CRAY
RESEARCH (UK) LTD

RE : TECHWAY DRAWINGS - COMMENTS

Electrical Drawings

V84/347-406
V84/347-401/1
V84/374-405
V84/347-404
V84/374-407
V84/374-411

DIAGRAM A

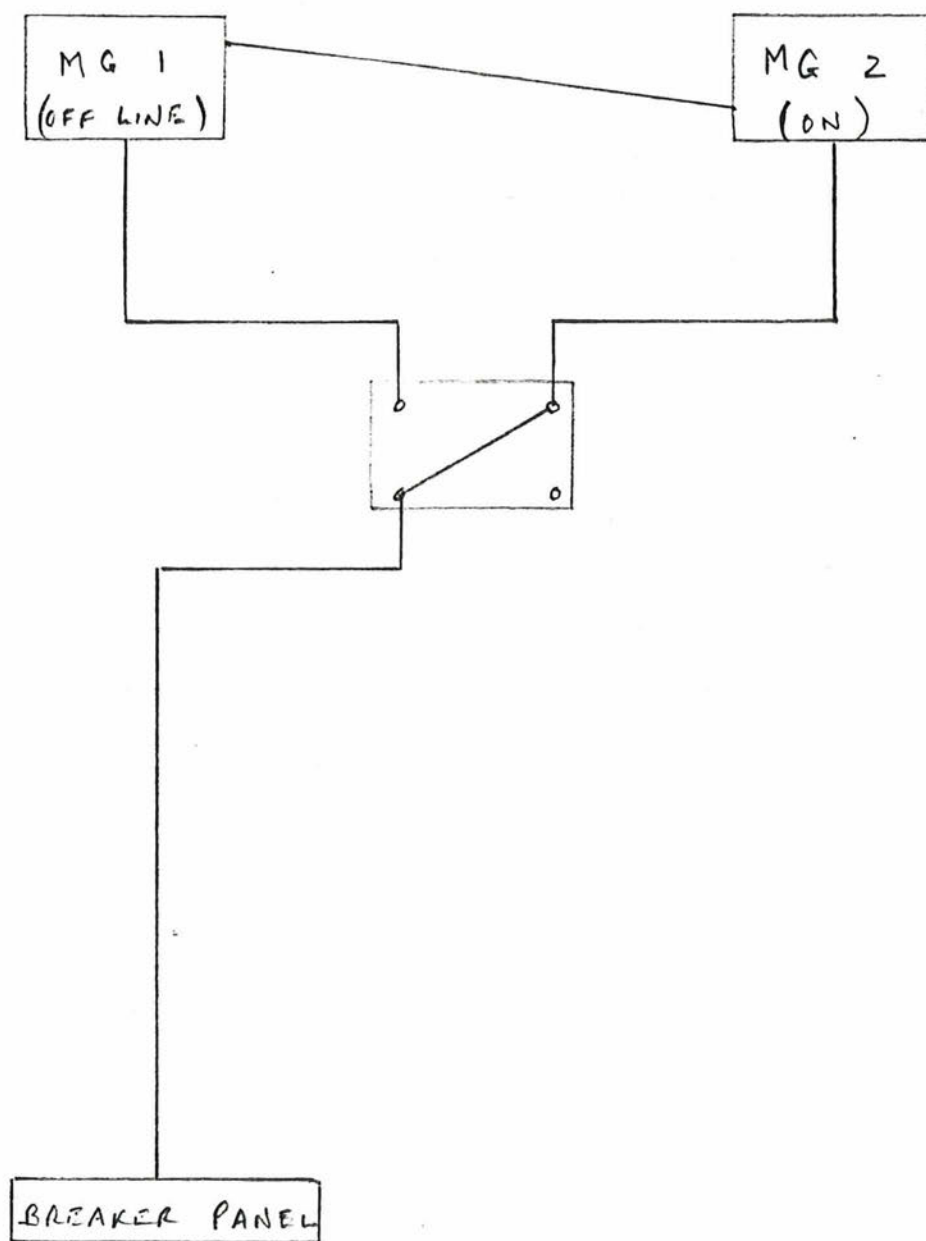
1.9 A compromise agreement was reached - to fit a Manual Changeover Link Box instead of a switch, as well as the standard internal changeover features and cabling. Diagram 'A' (attached) shows this.

In the case of a failure of MG 1, MG 2 would be powered on and connected to the Computer Room Breaker Panel via MG 1. At a convenient time, the connection of MG 2 could be made via the Changeover Link Box to allow work to be done on MG 1 with the system powered on.

MG 1 PROVIDES POWER
OR MG 2 PROVIDES POWER VIA MG 1
